# Bharat Heavy Electricals Limited

**BAP:IC:10GNETWORK:Amend-2**

<b>Subject</b>	<b>Tender Change Notice (TCN) - 02</b>
<b>Job</b>	<b>Design, Supply, Installation, Commissioning and Maintenance of Network Actives and Passives and Data Centre equipment for Campus Wide 10 Gigabit Network at BHEL, Ranipet on 5 Years Lease Rental Basis</b>
<b>Ref:</b>	1. Tender Notice : BAP:IC:10GNETWORK dt. 13.07.2011 2. BHEL's NIT_10206 dt. 13.07.2011

## 10G NETWORK LOCATIONS LAYOUT

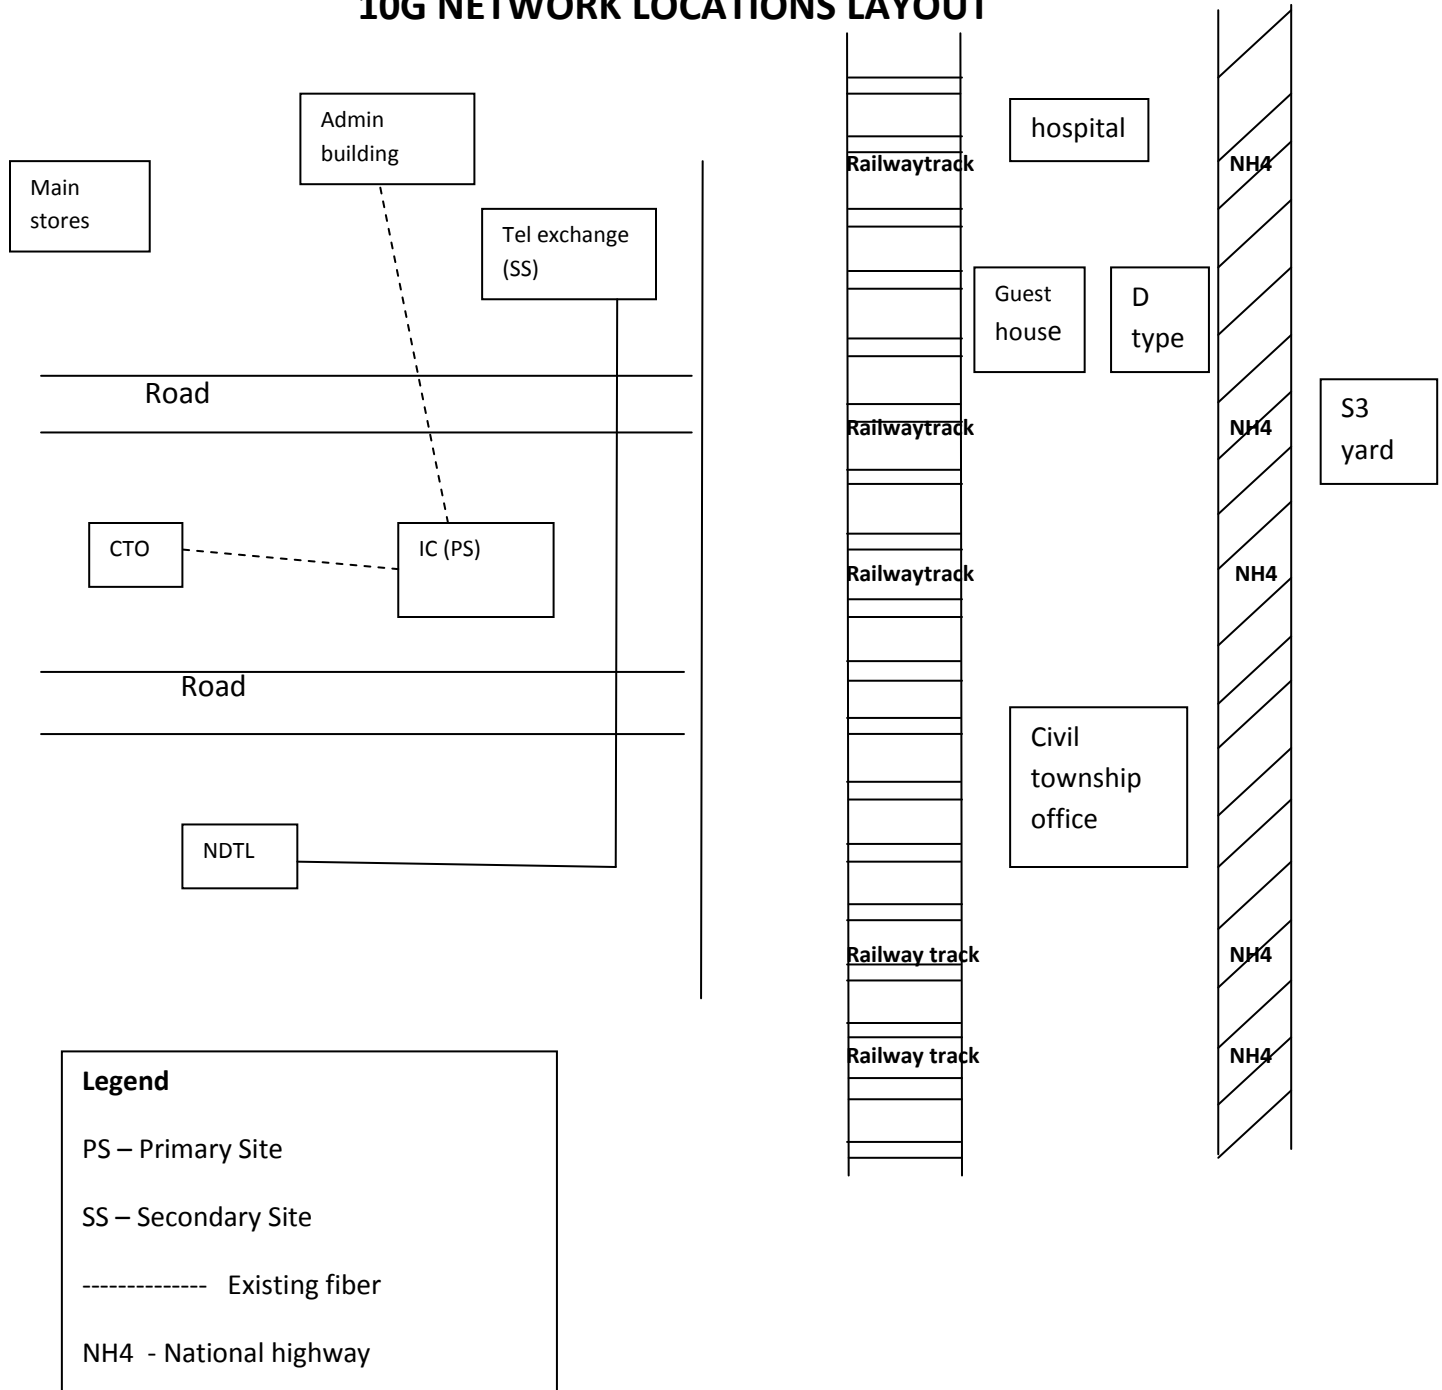
<b>S.No</b>	<b>Tender Reference</b>	<b>Earlier Tender description</b>	<b>Revised description</b>
1	Annexure-III- Page No.4	10 G Network Locations Layout Diagram	10 G Network Locations Layout Diagram revised.
2a	Annexure-III – Page No.87	Supply UPS (N+N) and integrate the same	Size the UPS for PDC1 and PDC2 and Supply UPS (N+N) and integrate the same. UPS capacity should be arrived by the bidder design calculation but minimum 2X 80 KVA should be considered
2b	Annexure-III – Page No.87	Supply Generator Set and integrate the same	Size Genset for Data Center (PDC1 & PDC2) and size Genset for DR and Supply Generator Set and integrate the same. Gen set capacity
